Access Compliance Report

Public Rights-of-Way

(Pedestrian Signals)

Intersection ID: N/A	Main Street:	Cross Street: N/A	Location: N/A
ADA ID: 80ECAA10C714	Signal Type: One Push Button-Non APS	Overall Compliance: No	Severity Score: BTN 1: N/A BTN 2: N/A No BTN: N/A
Codes/Mitigation Info/Possible Solution		Field Measurements/Component Compliance

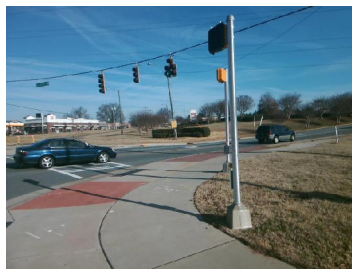
Possible Solutions: Replace Signal Push Button With APS Button on New Post. Remove & Relocate Sign.

PROW/ADA: TMUTCD 4e.08, R404.2, R404.3, R404.7.2
